INCH-POUND
MIL-C-24758/7(SH)
AMENDMENT 1
23 September 1994

MILITARY SPECIFICATION SHEET

CONDUIT, FLEXIBLE, WEATHERPROOF, CONDUIT-TO-STUFFING TUBE (MIL-S-24235) FITTING

This amendment forms a part of MIL-C-24758/7(SH), dated 5 August 1991, and is approved for use by all Departments and Agencies of the Department of Defense

"TABLE I A-Thread code and adapter dimensions

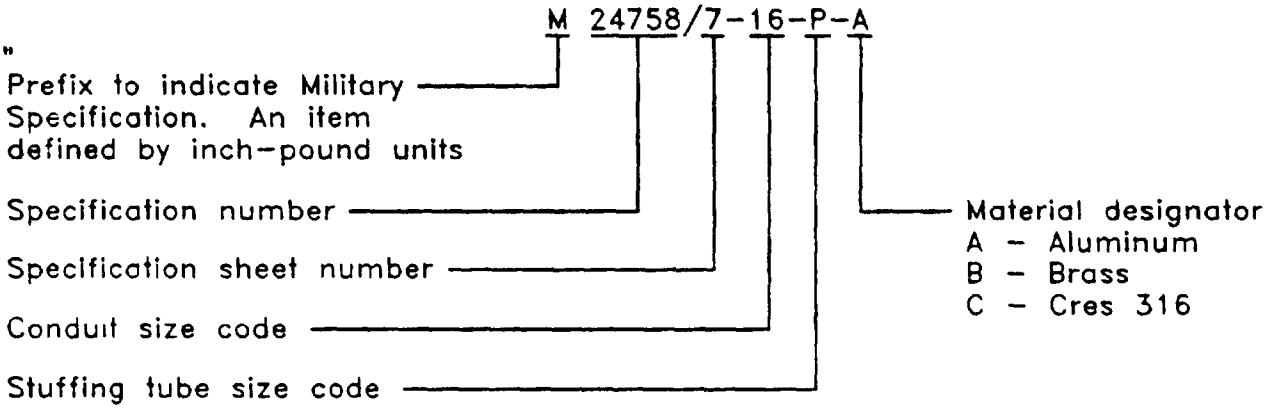
TABLE I. Delete and substitute.

Notes to Table I: Add "5 The maximum "P" dimension of the M24758/7 fitting should be larger than the outside dimension of the thread on the side of the adapter which interfaces with the conduit."
